L624-A.04.16	To: Official After Sales Network Subject: TPMS control unit holder replacement Date: March 18,2016 Pages 2	
--------------	-------------------------------------------------------------------------------------------------------------------------------------------------	-------------------------------------------------------------------------------------

TPMS control unit holder replacement .

Huracàn Coupè.

From **FLA00163** to **FLA03965**.

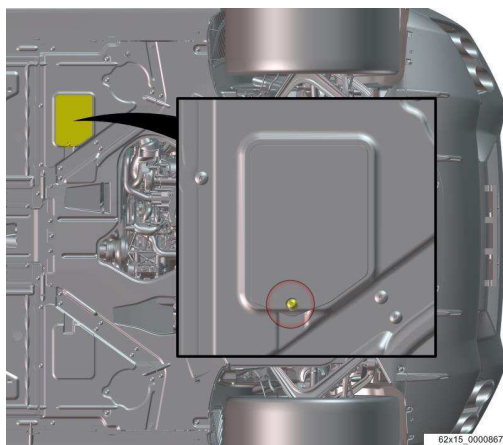
1. Place the car on a suitable lift.
2. TPMS control unit holder disassembling.

Remove the screw that fasten the TPMS plastic cover and then consequentially the cover itself.

Fixing Screw.

Torque: **4 Nm.**

62x15_0000868

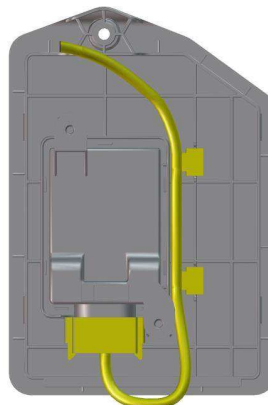
Remove the fastening clip from the cover and then unplug the connector from the TPMS control unit.
